7.7 Control Systems Not Required for Safety

The information in this section of the reference ABWR DCD, including all subsections and figures, as modified by the STP Nuclear Operating Company Application to Amend the Design Certification rule for the U.S. Advanced Boiling Water Reactor (ABWR), "ABWR STP Aircraft Impact Assessment (AIA) Amendment Revision 3," dated September 23, 2010 is incorporated by reference with the following departures and supplements.

Figure 7.7-11 Simplified Functional Diagram of the Automatic Power Regulation System

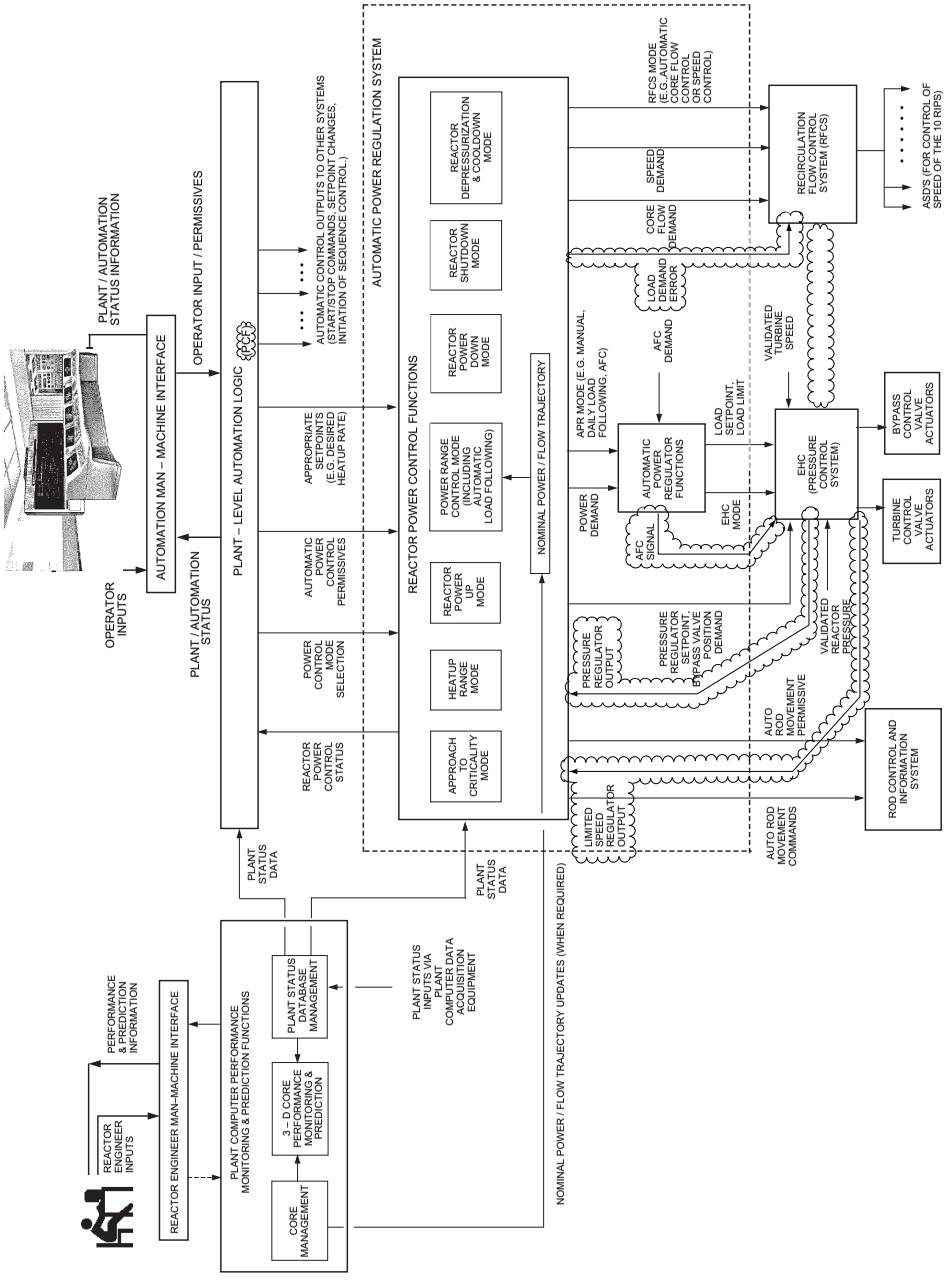
STD DEP 7.7-20 (Figures 7.7-5, 7.7-7, 7.7-11)

STD DEP 7.7-24 (Figures 7.7-11, 7.7-12, 7.7-13)

The primary objective of the Automatic Power Regulator (APR) System is to control reactor power during reactor startup, power generation, and reactor shutdown, by appropriate commands to change rod positions, or to change reactor recirculation flow. The secondary objective of the APR System is to control the pressure regulator setpoint (or turbine bypass valve position) during reactor heatup and depressurization (e.g., to control the reactor cooldown rate). The APR System consists of redundant process controllers. Automatic power regulation is achieved by appropriate control algorithms for different phases of the reactor operation which include approach to criticality, heatup, reactor power increase, automatic load following, reactor power decrease, and reactor depressurization and cooldown. The APR System receives input from the ~~plant computer~~PCF, the Power Generation Control System (Subsection 7.7.1.5.~~1~~2), the Steam Bypass and Pressure Control System (Subsection 7.7.1.8), and the operator's control console. The output demand signals from the APR System are to the RCIS to position the control rods, to the RFC System to change reactor coolant recirculation flow, and to the SB&PC System for automatic load following operations. The ~~PGS~~PGCS performs the overall plant startup, power operation, and shutdown functions. The APR System performs only those functions associated with reactor power changes and with pressure regulator setpoint (or turbine bypass valve position) changes during reactor heatup or depressurization. A simplified functional block diagram of the APR System is provided in Figure 7.7-11.
